August 25, 2025

RE: 58 Humphreys Court

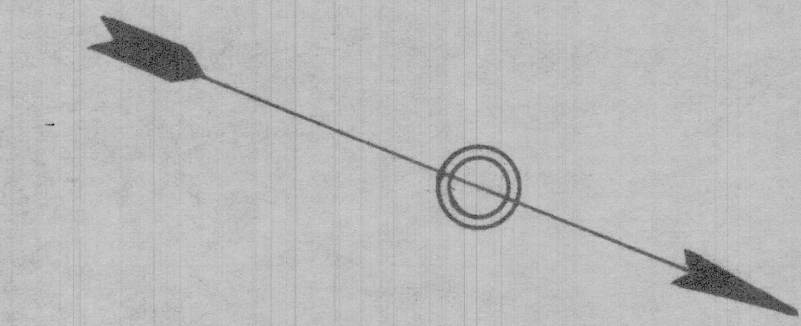
3. Setbacks and Building Area. Separate from the basic dimensional requirements, the Applicant's proposed subdivision plan shows setback lines, and the resulting buildable area on each lot. The Applicant's initial submittal included conceptual building footprints within the buildable area, but with certain encroachments into the required setbacks, which this Committee noted at the June 10 meeting. The Applicant's resubmittal omitted the conceptual buildings, presumably to avoid addressing the issue of the setback encroachments. Nonetheless, before granting a subdivision approval, the City should require the Applicant to demonstrate that the resulting lots will be developable, by showing sufficient buildable area for construction of the proposed homes, including taking into account the additional 10% setback required of corner lots due to visibility and safety concerns. If the

proposed homes cannot be built in compliance with the necessary setbacks, the subdivision should not be granted in the first place, as the Applicant is creating its own hardship, and thereby undermining any basis to request zoning relief for any setback encroachments thereafter.
